1st Further Information

**Temporary Open Storage of Construction Materials and Machineries with Ancillary Facilities
for a Period of 3 Years and Associated Filling of Land in “Residential (Group D)” Zone,
Lot 55 (Part) in D.D. 108, Pat Heung, Yuen Long, New Territories**

(S.16 Planning Application No. A/YL-PH/974)

Responses-to-Comments

DWG NO. PLAN 1	VER. 001
-------------------	-------------

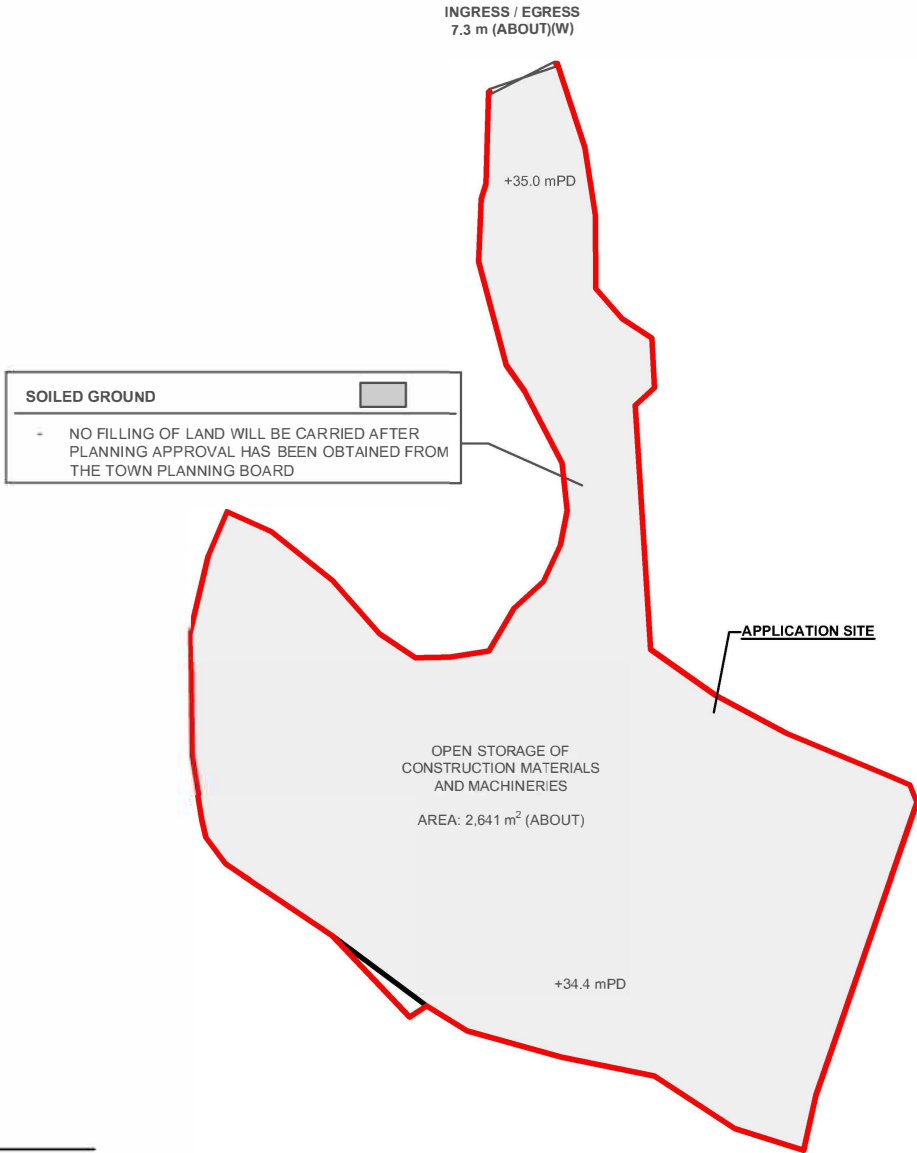
Departmental Comments		Applicant's Responses
1. Comments of Commissioner for Transport (C for T) (Contact Person: Mr. Phil CAI; Tel: 2399 2421)		
(a)	The applicant should demonstrate the smooth manoeuvring of vehicles to/from Fan Kam Road and along the local access;	A swept path analysis is provided to demonstrate the smooth manoeuvring of vehicles to/from Fan Kam Road and along the local access (Plan 1).

DWG NO. ANNEX I VER. 002

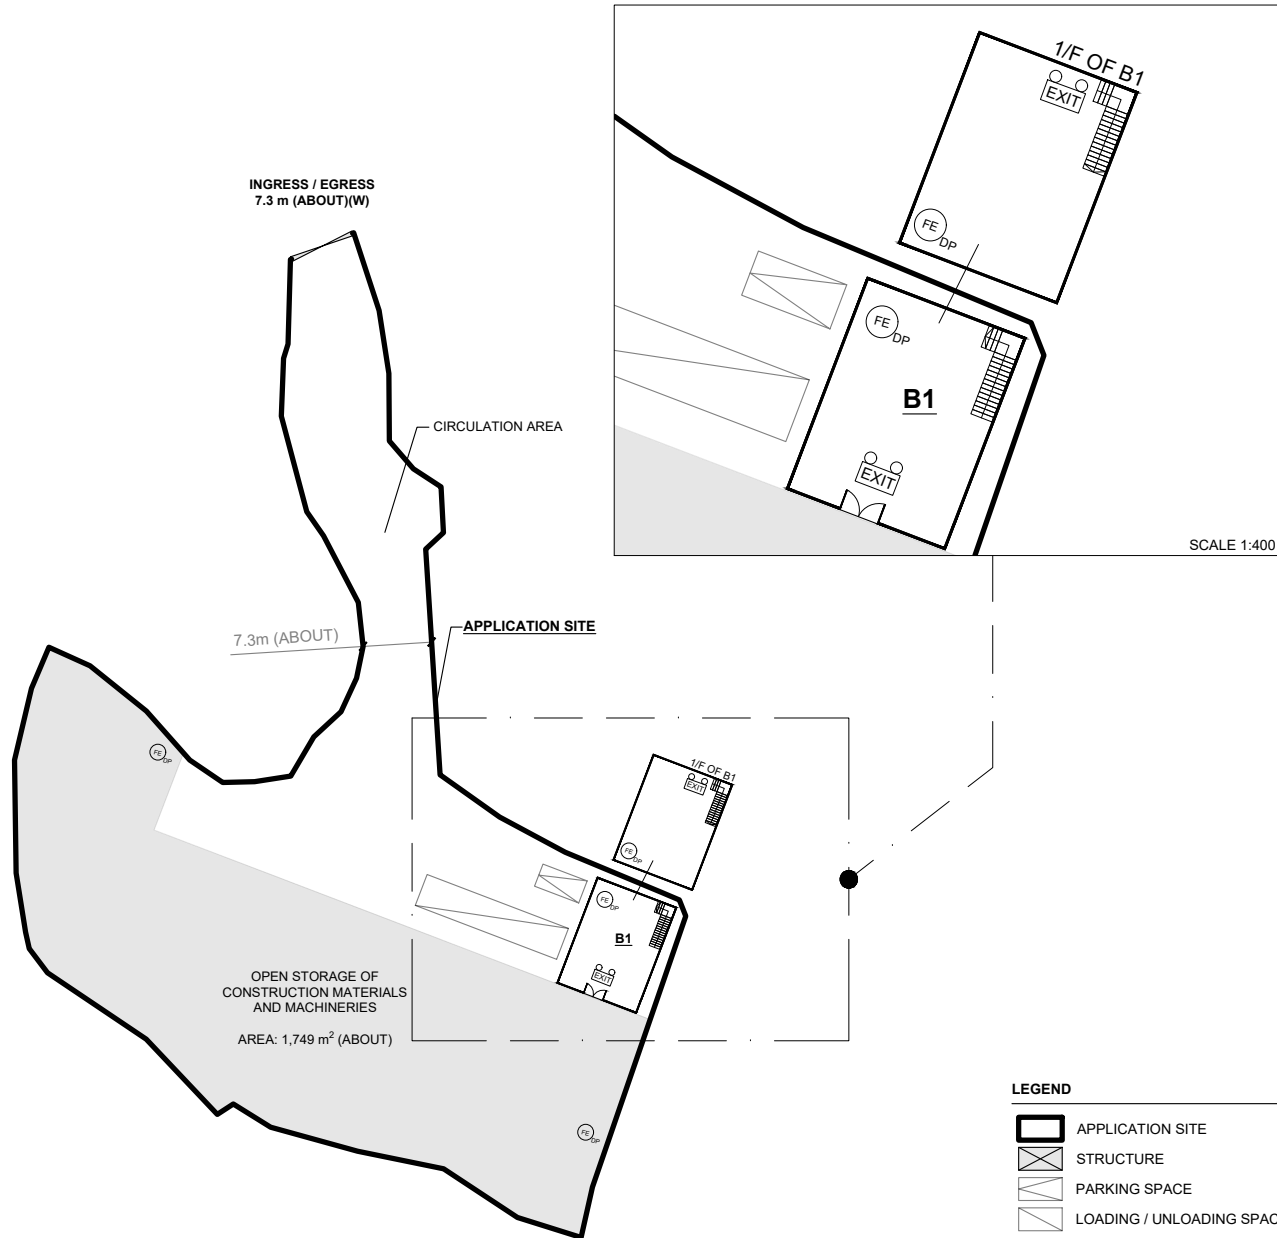
4. Comments of Director of Fire Services (D of FS) (Contact Person: Mr. CHAU Nai-yin; Tel: 2733 7781)		
(a)	Sufficient portable fire extinguishers shall be provided to the open storage area;	A revised fire service installations proposal, showing the provision of fire extinguishers, is provided for your consideration (Annex I).

Title:
 Drainage layout

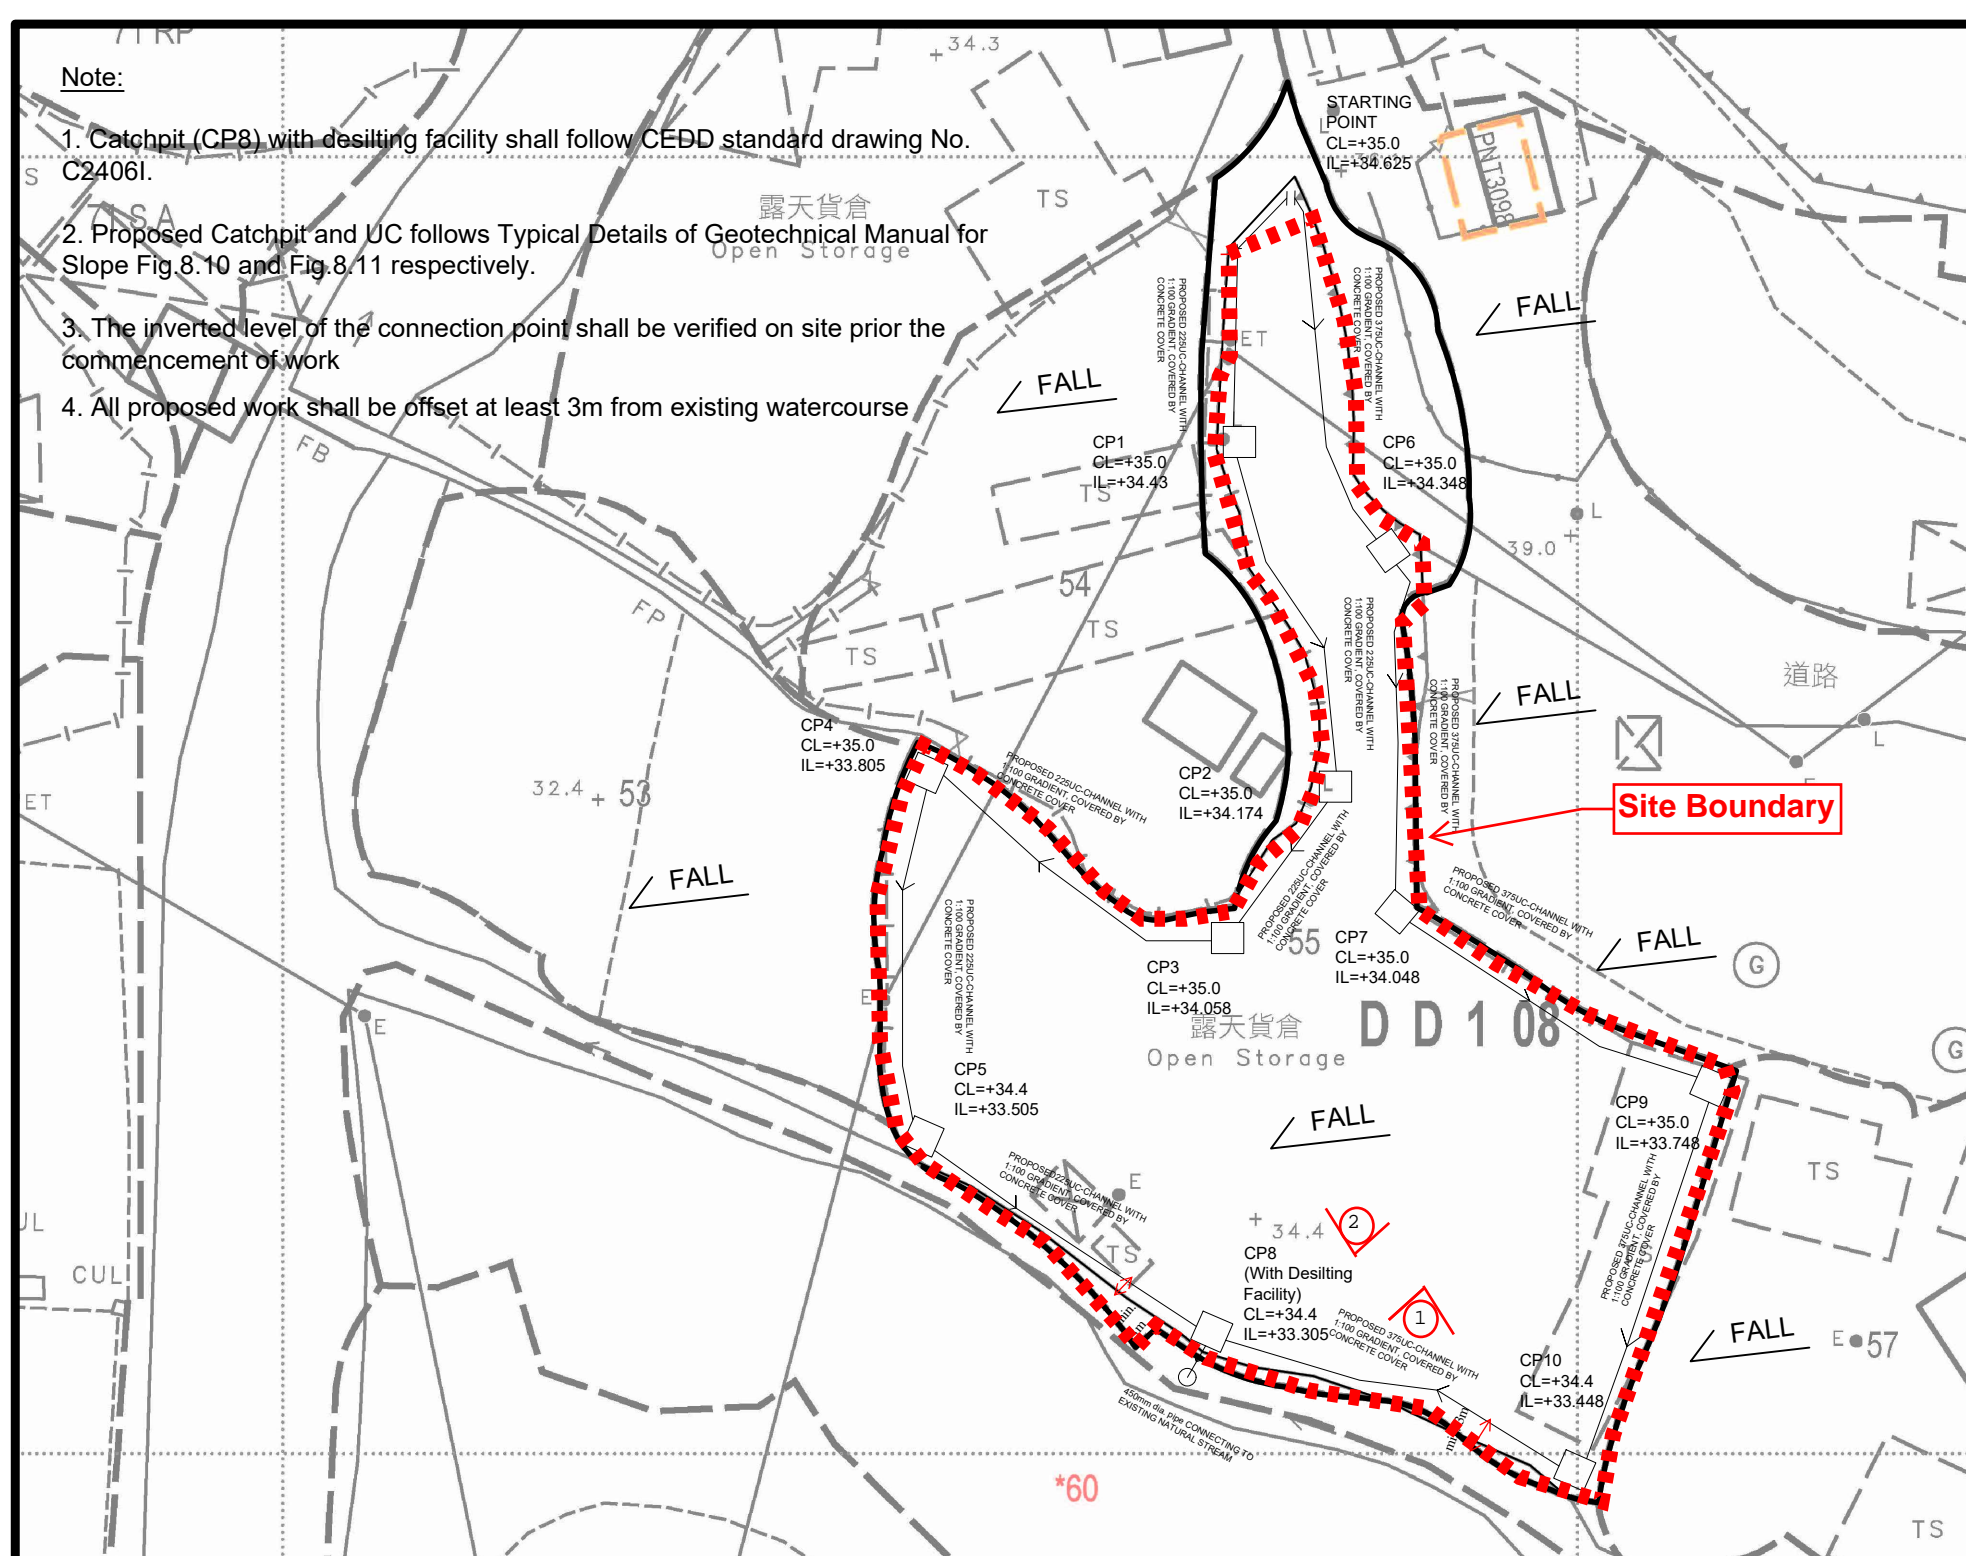
5. Comments of Chief Engineer/Mainland, Drainage Services Department (CE/MN, DSD) (Contact Person: Mr. Terence TANG; Tel: 2300 1257)		
(a)	The size of discharge pipe is not consistent on drainage plan, calculations and section drawings. Please revise accordingly.	A revised drainage proposal is provided for your consideration (Annex II). Please be noted that the discharge pipe is revised accordingly and 450mm of dia. Pipe is proposed.

(b)	Please indicate the 3m offset from watercourse and also all your proposed structures on plan for reference.	It is indicated accordingly and the statement "All proposed work shall be offset at least 3m from existing watercourse" is indicated in Note of drainage layout plan.

1. Catchpit (CP8) with desilting facility shall follow CEDD standard drawing No. C24061.
2. Proposed Catchpit and UC follows Typical Details of Geotechnical Manual for Slope Fig 8.10 and Fig.8.11 respectively.
3. The inverted level of the connection point shall be verified on site prior the commencement of work
4. All proposed work shall be offset at least 3m from existing watercourse

PHOTO13: AERIAL PHOTO of EXISTING WATERCOURSE CONDITION

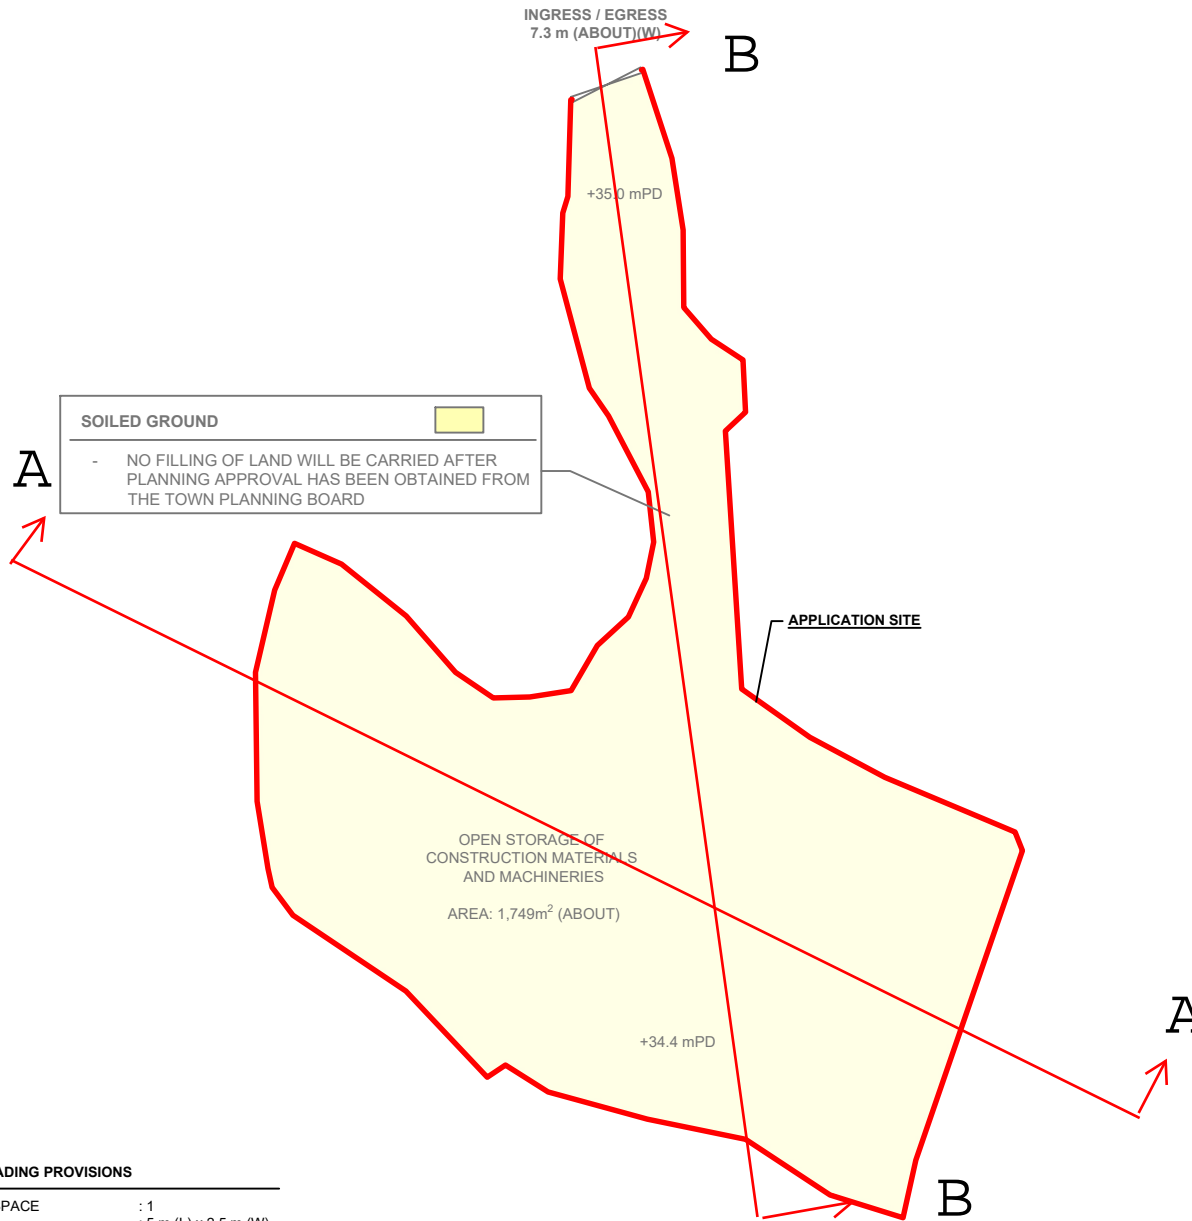
(c)	The submitted photo does not show the existing watercourse bank condition clearly. Please retake.	Photo of existing watercourse bank condition (Photo 3) is provided for your reference but it was found that the bank mostly covered by greensward and plants.
-----	---	---
